Cottam Solar Project

Figure 8.16.5: Landscape and Ecology Mitigation and Enhancement Plan – Cottam 1 South (Sheet 2) Revision A

Document reference: EX1/C6.4.8.16.5_A

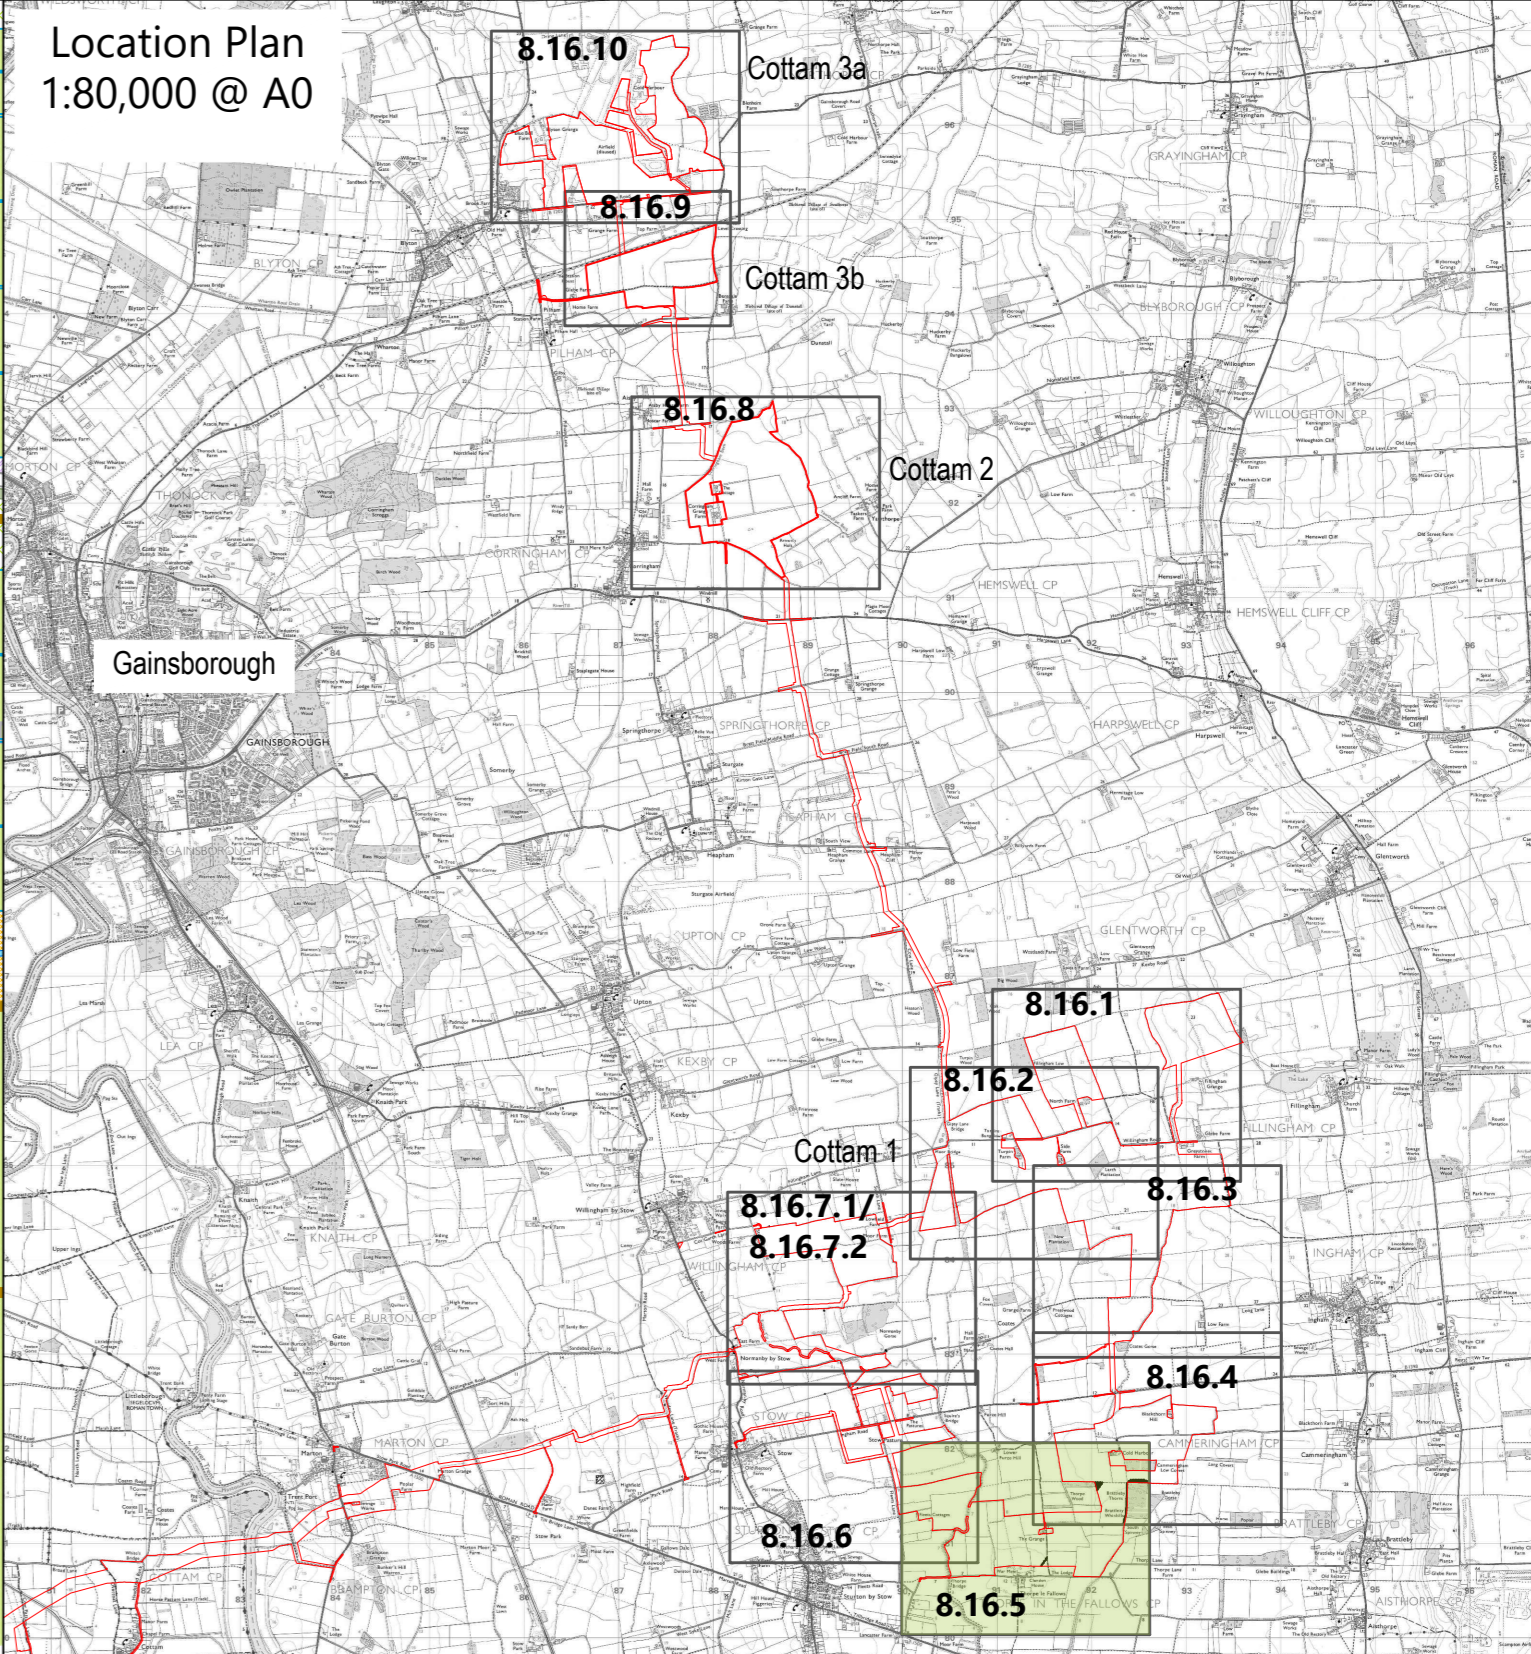
Figure Reference	Page	Description of Changes	Reason for Revision
Figure 8.16.5	3	Change to spelling of 'enhancement'. Offset calculations from drains. Additional Hedgerows to be removed.	For clarity and consistency. To correct a typo.
